# REPORT FOR ACTION

# 220, 230 and 240 Lake Promenade and 21 and 31 Park Boulevard – Official Plan Amendment, Zoning By-law Amendment, and Draft Plan of Subdivision Applications – Appeal Report

Date: November 14, 2024

Planning Application Numbers: 23 134668 WET 03 OZ and 23 134682 WET 03 SB

**Draft Plan of Subdivision**

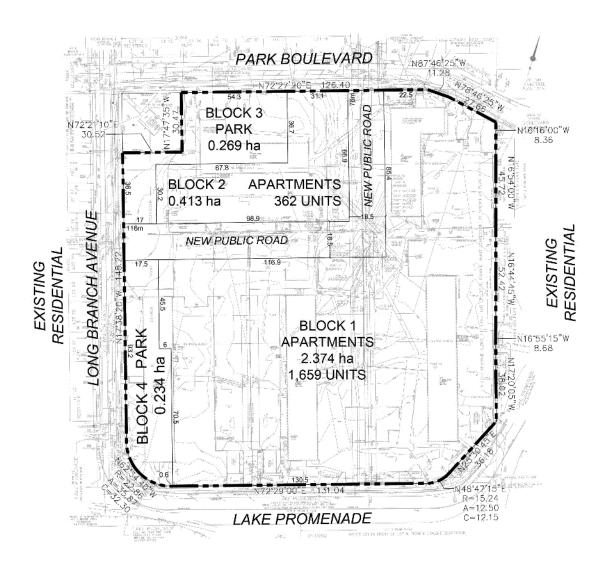
- The non-alignment of the north-south portion of the new public street with Thirty Third Street is not ideal.

The TIS includes a Road Functional Design that shows a 2.04-metre offset between the alignments of the centre-lines of Thirty Third Street and the proposed Thirty Third Street extension, which is not acceptable to Transportation Services staff. A revised proposal is required to eliminate the offset.
